Subject: Final Report - DER 84-38
A 50.55(e) Reportable Condition Relating To Improperly Welded
Flange In Unit 2.
File: 84-019-026; D.4.33.2

FINAL REPORT - DER 84-38
DEFICIENCY EVALUATION 50.55(e)
ARIZONA PUBLIC SERVICE COMPANY (APS)
PVNGS UNIT 2

FIGURE 1

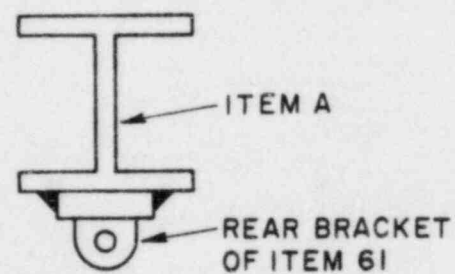
Pipe support #13-AF-005-H-007, Rev. 1, was installed and accepted in Unit 2 by Field Engineering and Quality Control in November of 1981. The existing documentation required the miscellaneous steel (Item A) to be installed at an evaluation of 85'-0 3/4" and the beam attachment of sway strut (Item 61) to be welded to Item A on the north and south sides (see Figure 1). Documentation was prepared in March of 1984 to partially disassemble this support for piping rework. Upon completion of the piping work and reassembly of the support, two discrepancies in the original installation were noted in NCR PC-8250:

1. The miscellaneous steel (Item A) is installed at elevation 85'-3".
2. The rear bracket (of Item 61) is welded on the east and west sides.

The change in elevation of miscellaneous steel (Item A) also lengthened the overall dimension from beam bracket to centerline of pipe of sway strut (Item 61) from 2'-8 3/4" to 2'-11". This causes no additional loading or induced stresses in Item A and the existing sway strut length is still within vendor requirements for the design loading condition so the structural integrity of the pipe support is not degraded.

However, with the beam attachment welded on the east and west sides, the bottom flange of Item A will not induce loads to the structural member as intended. This results in exceeding the structural capacity of the bottom flange during a DBE. Once the capacity of the support has been exceeded, piping stresses will reach unacceptable levels. Based upon the above, this condition is evaluated as reportable under the requirements of 10CFR50.55(e); since, if left uncorrected, it would be a significant safety hazard.

- A. NCR PC-8290 will be dispositioned repair to add additional weld on the north and south sides of the beam attachment.
- B. As part of the corrective action identified in the response to the NRC Enforcement Letter and Notice of Violations, dated 12/12/83 (Violations II.B.3 and II.B.4), Bechtel Construction initiated a comprehensive reinspection program established under WPP/QCI 543.0. This reinspection program included 2199 pipe supports and pipe racks in Unit 1. All nonconforming conditions noted during the reinspection program were documented on NCRs PX-7370 and PA-7313. The "as-built" calculations indicate that the installed conditions of all welding nonconformances are sufficient to carry the project design loads. Therefore, the installed pipe supports were found to be acceptable without repair.
